Access Compliance Report

Public Rights-of-Way

(Curb Ramps)

Intersection ID: 28344	Main Street: BELLHAVEN_WALK_CT	Cross Street: BRIDGEHAMPTON_CLUB_DR	Location: NW
ADA ID: 270AB6668BFC	Ramp Type: Perp	Initial Pass/Fail: Fail	Overall Compliance: No
Severity Score: 25			
Codes/Mitigation Info/Possible Solution		Field Measurements/Component Compliance

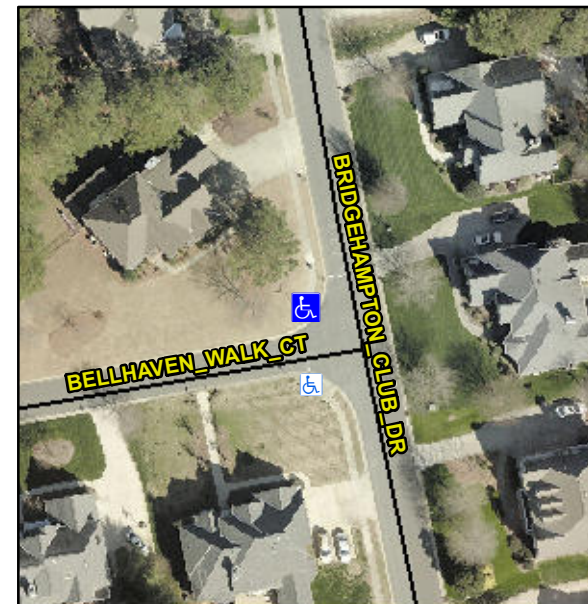
Not Found, R304.5.3

Compliance	Description	Data	Compliance	Description	Data
N/A	Ramp Length (in)	47.0	Yes	Ramp Slope (%)	7.5
Yes	Ramp Width (in)	49.0	No	Ramp XSlope (%)	7.2
N/A	Flare Type LT	N/A	N/A	Flare Type RT	N/A
N/A	Flare Slope LT (%)	N/A	N/A	Flare Slope RT (%)	N/A
N/A	Flare Traversable LT?	N/A	N/A	Flare Traversable RT?	N/A
N/A	Landing Length (in)	N/A	N/A	DWS Provided?	N/A
N/A	Landing Width (in)	N/A	N/A	DWS Contrast?	N/A
N/A	Landing Slope (%)	N/A	N/A	DWS Length (in)	N/A
N/A	Landing X Slope (%)	N/A	N/A	DWS Full Width?	N/A
N/A	Landing Curb? (Y/N)	N/A	N/A	DWS Offset (in)	N/A
N/A	Shared Landing?	N/A			
N/A	Gutter Ponding?	N/A	N/A	Gutter Slope (%)	N/A
N/A	Gutter Lip Ht (in)	N/A	N/A	Gutter X Slope (%)	N/A
N/A	Painted X Walk1?	No	N/A	Painted X Walk2?	N/A
	X Walk 1 Direction	To S		X Walk 2 Direction	N/A
N/A	X Walk 1 Width (in)	N/A	N/A	X Walk 2 Width (in)	N/A
	X Walk 1 Slope (%)	0.3		X Walk 2 Slope (%)	N/A
	X Walk 1 X Slope (%)	2.0		X Walk 2 X Slope (%)	N/A

Remove & Replace Entire Ramp.
